Re: New Industrial Live/Work (**MLDFY2023-0002**)
Plan Review and City Engineer Comments

MLD Planning Office Report Corrections/Comments - 2

City Engineer Review Comments – 2 February 2024

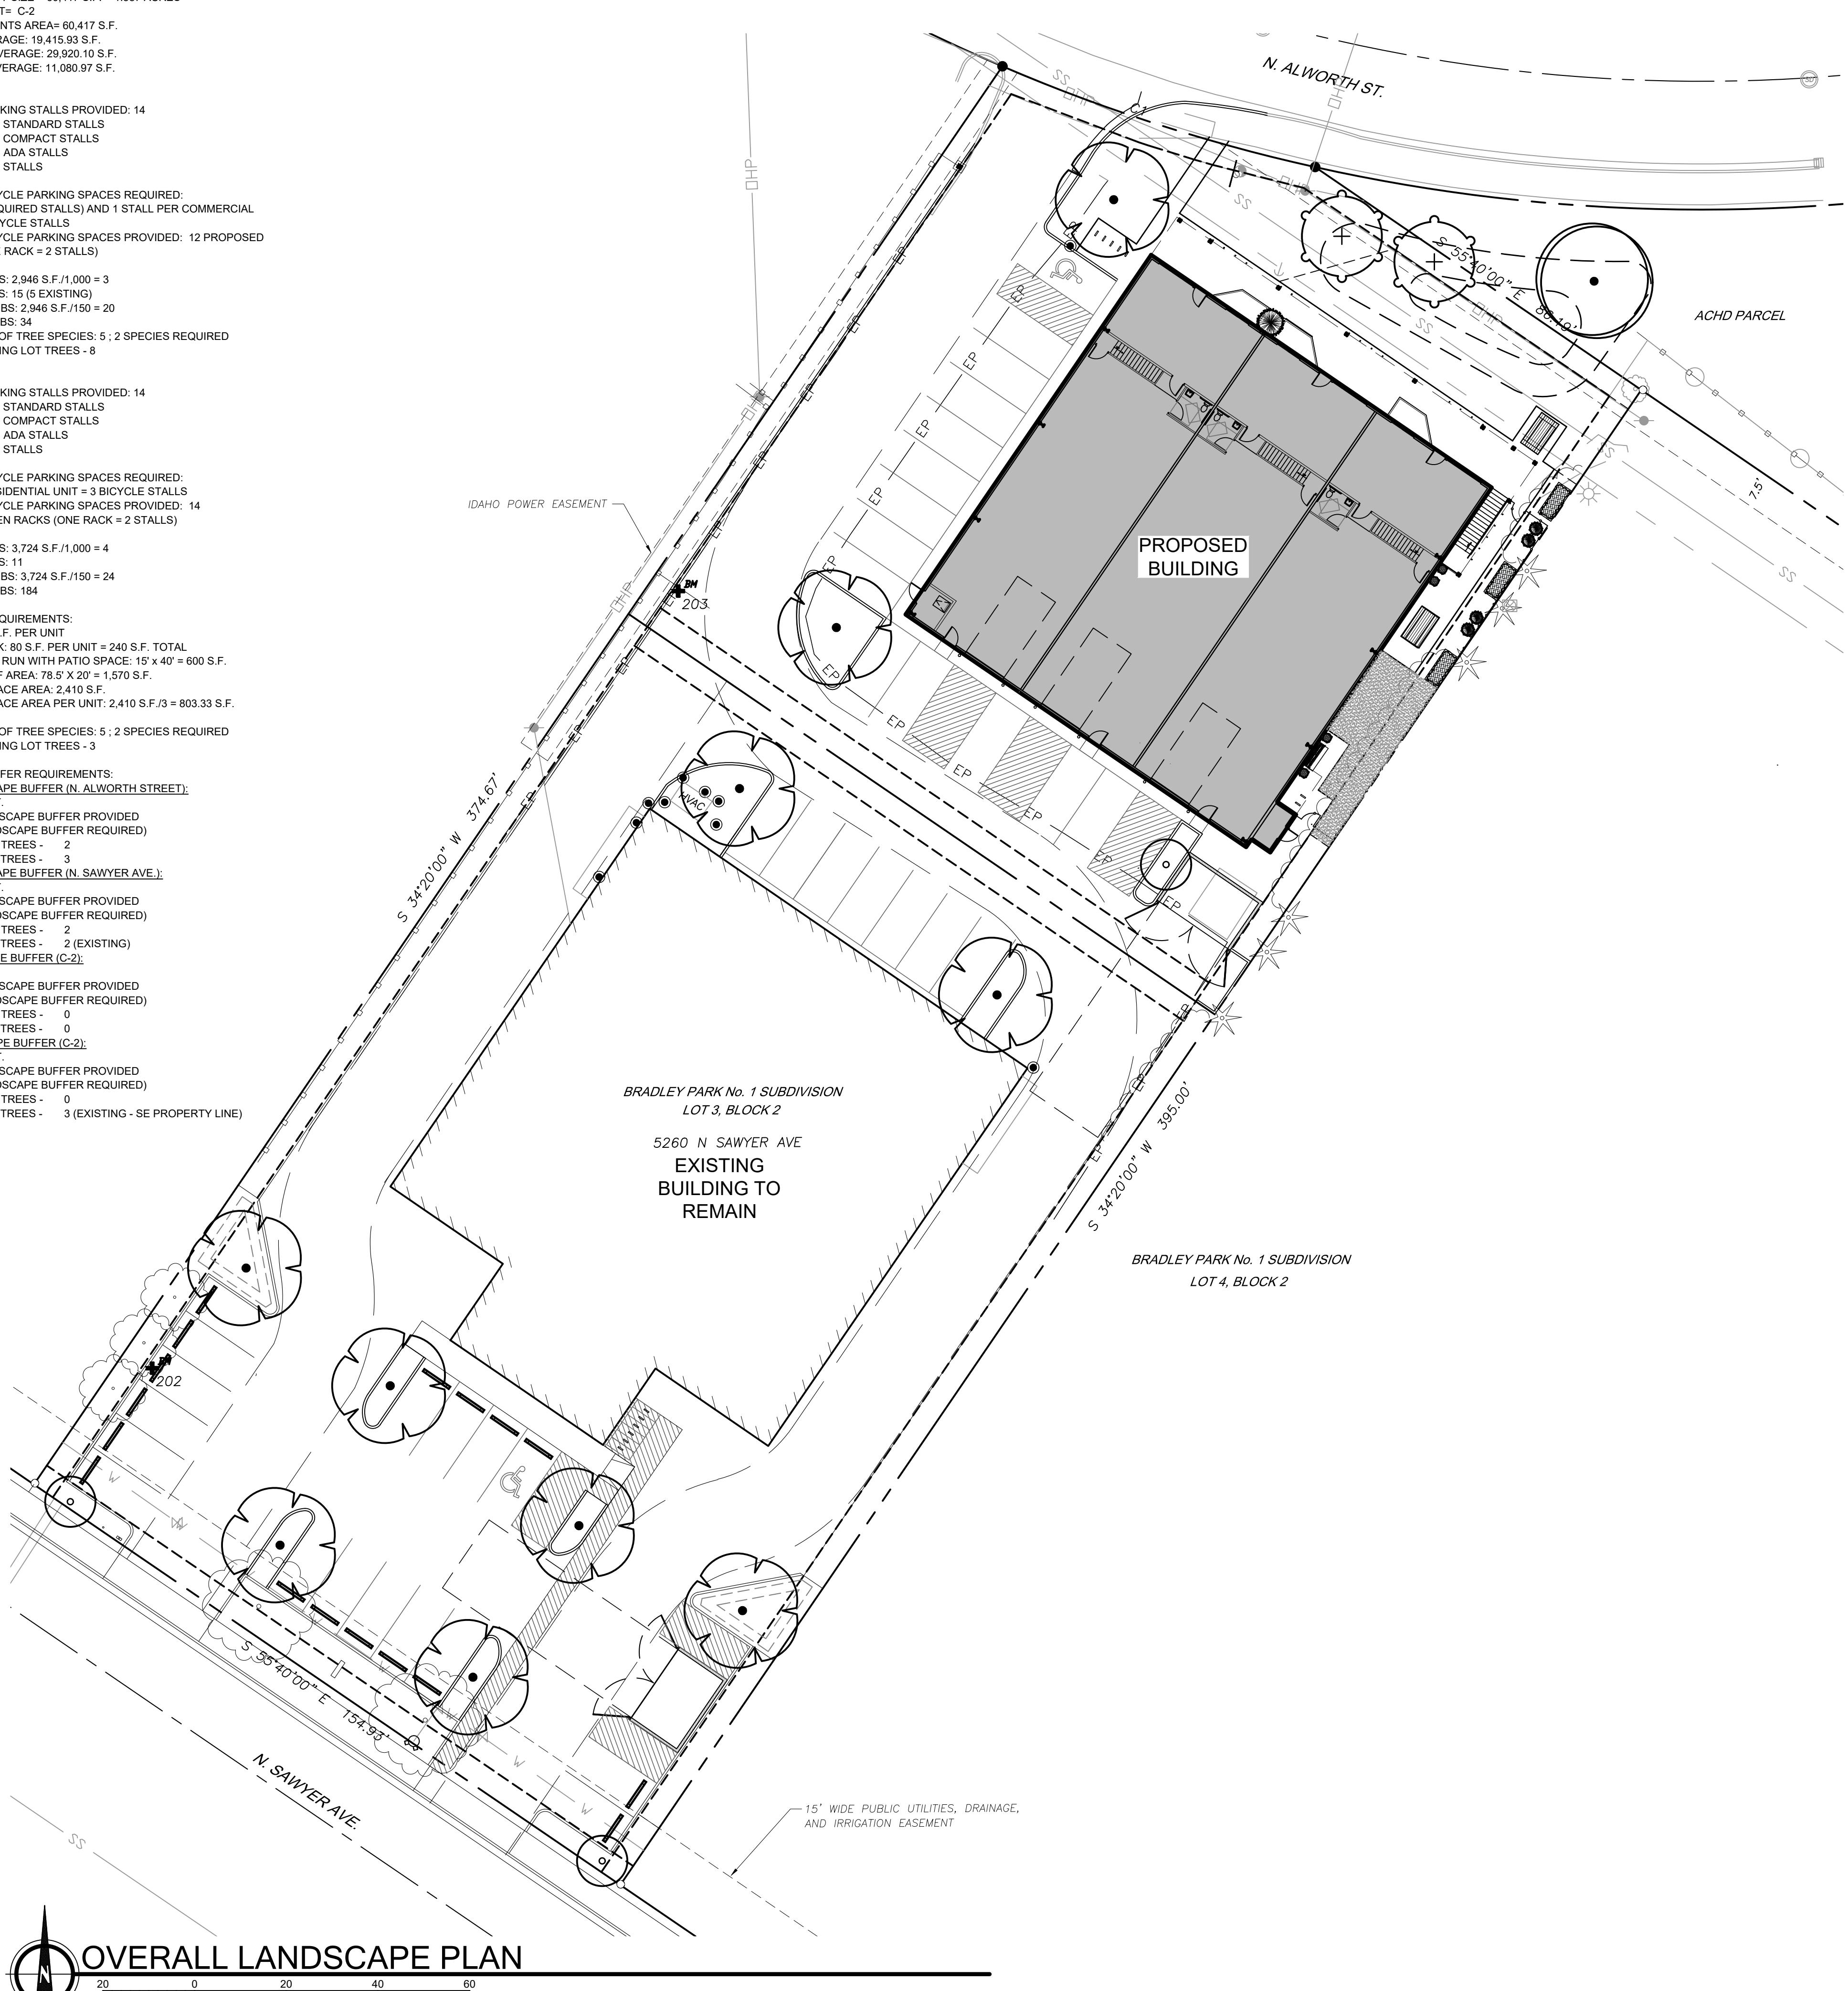
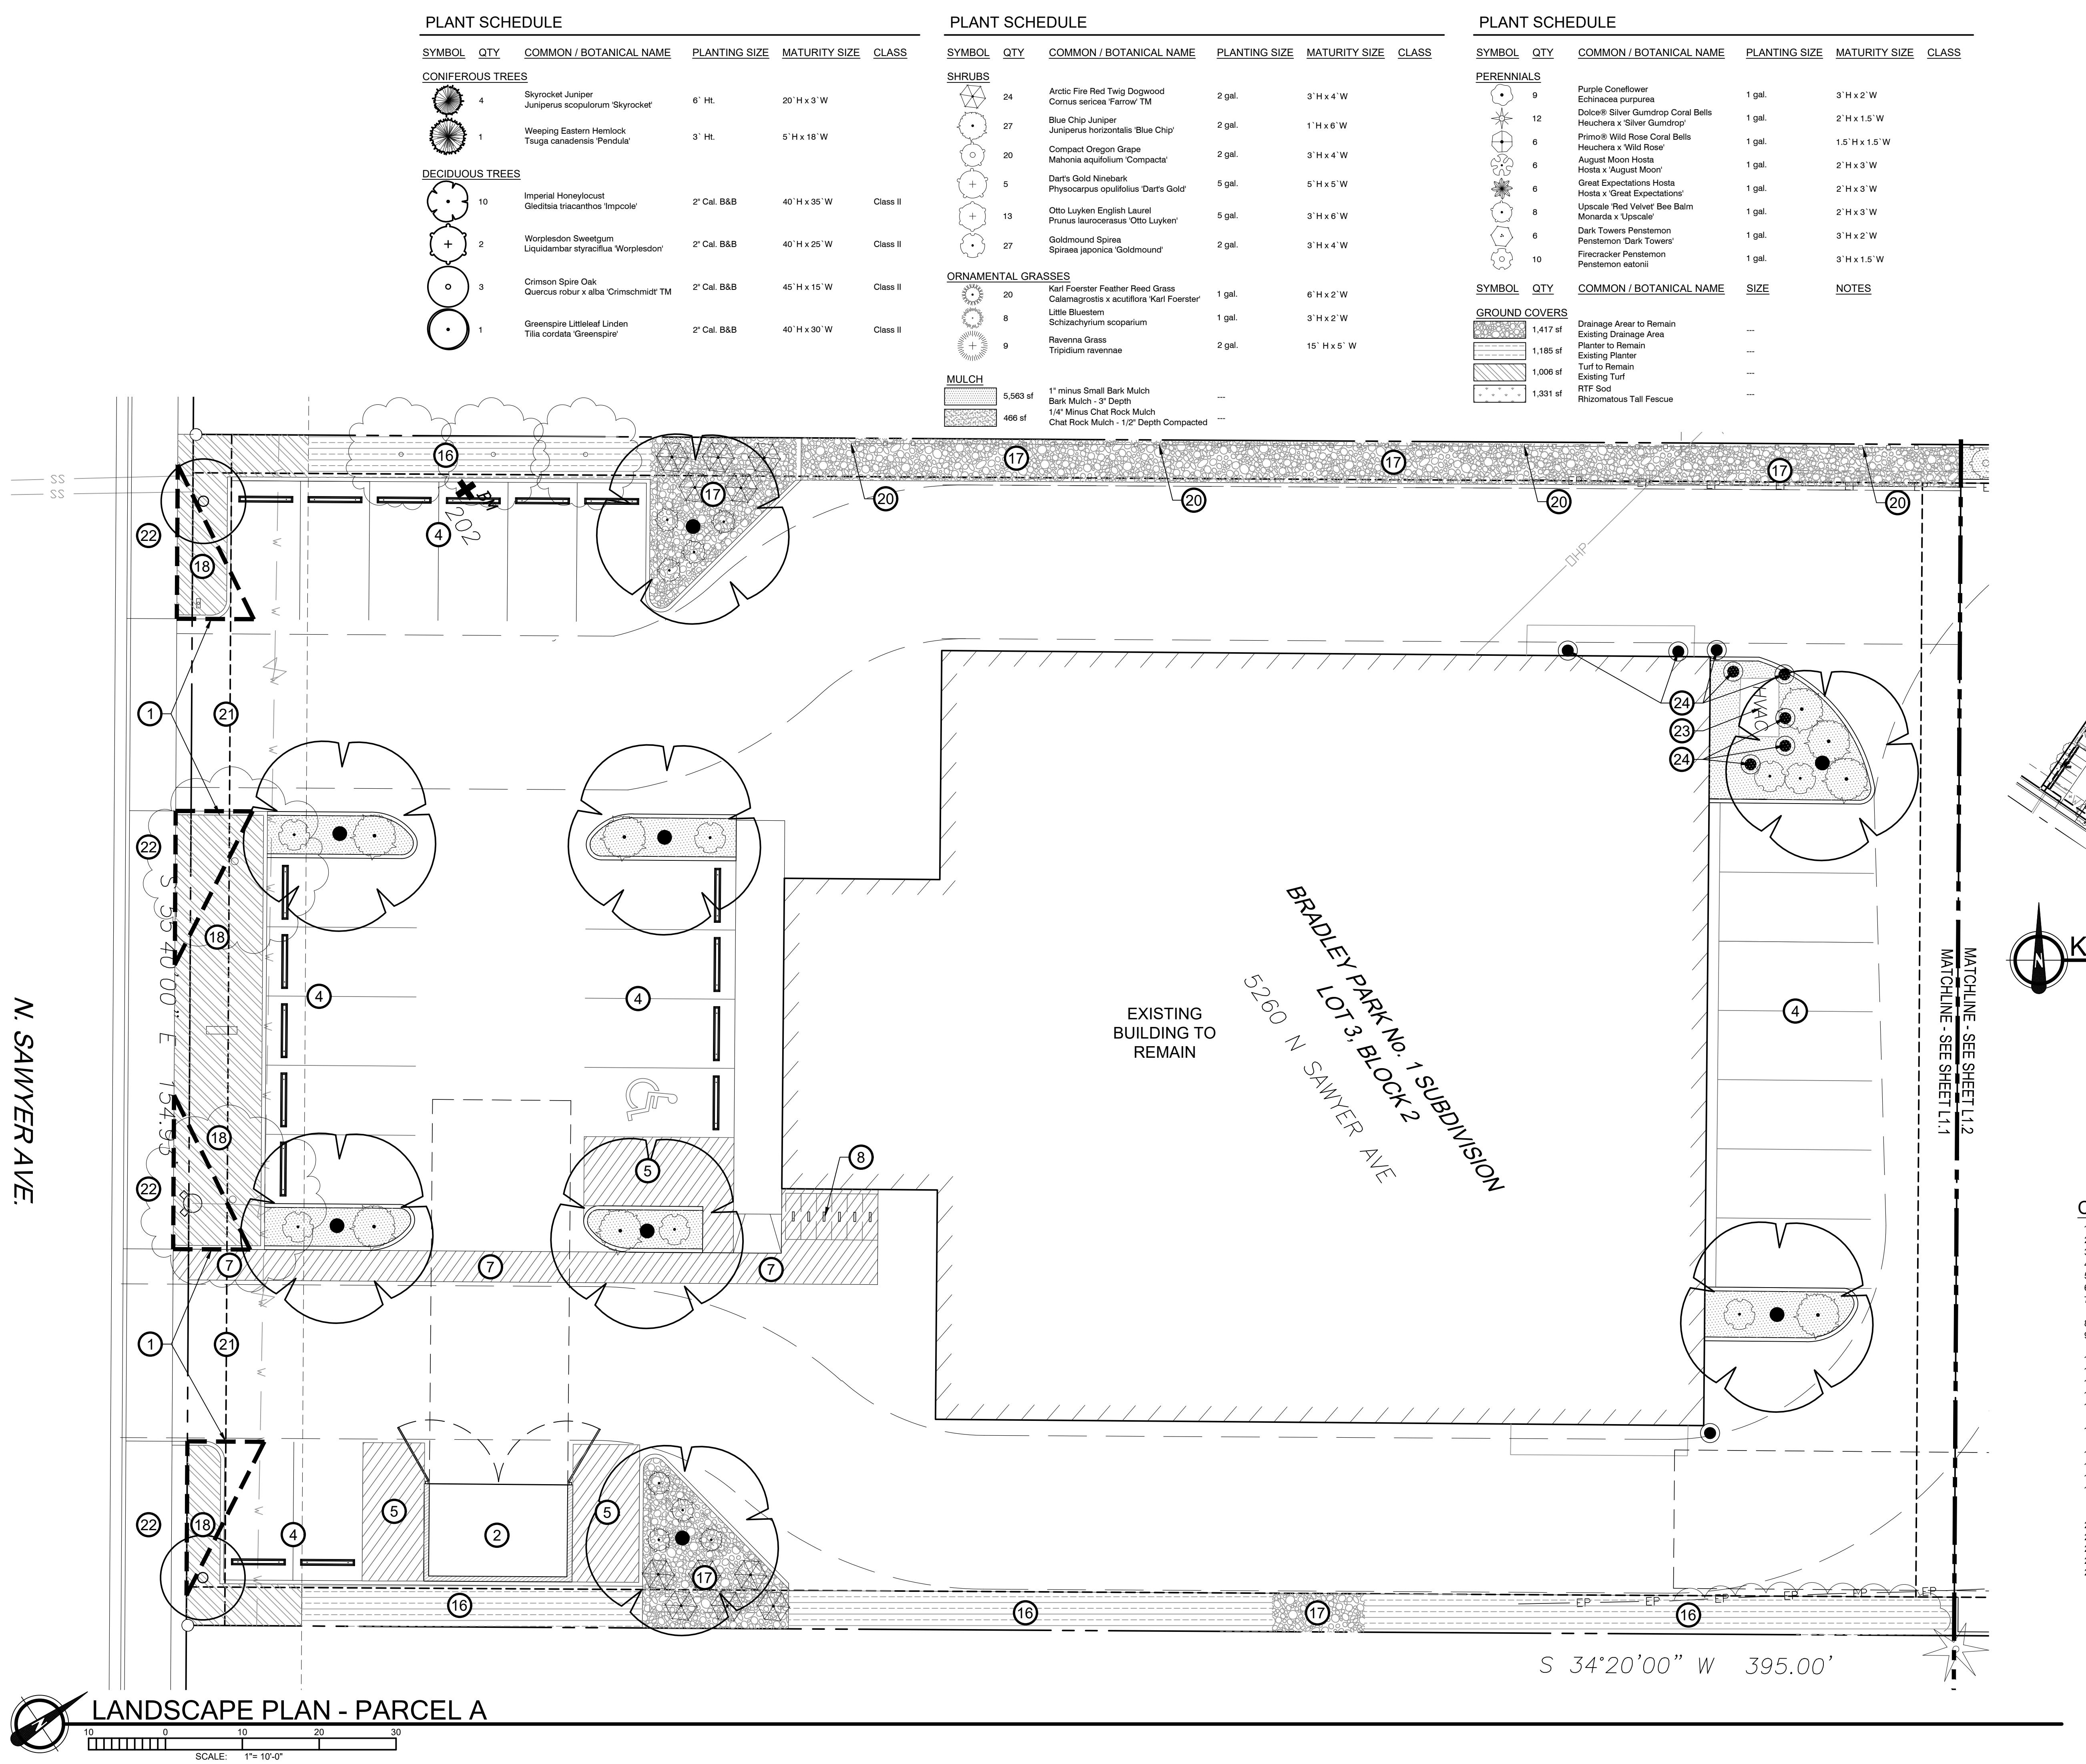
Item 11: *New landscape plans shall be submitted showing compliance with Garden City Code 8- 4I-4.*

a. *A minimum of two additional Class II or III trees shall be planted in the frontage of N. Sawyer Ave.*

b. *A minimum of one tree per 1,000sqft of landscaped area and one shrub per 150sqft of landscaped area shall be planted.*

Response: See new sheets L1.0 and L1.1 for landscaping plans and calculations showing compliance with GC Code 8-4I-4, the two additional trees planted in the frontage of N. Sawyer Ave. and addressing requirements associated with previous CUP96-06-06 approval.
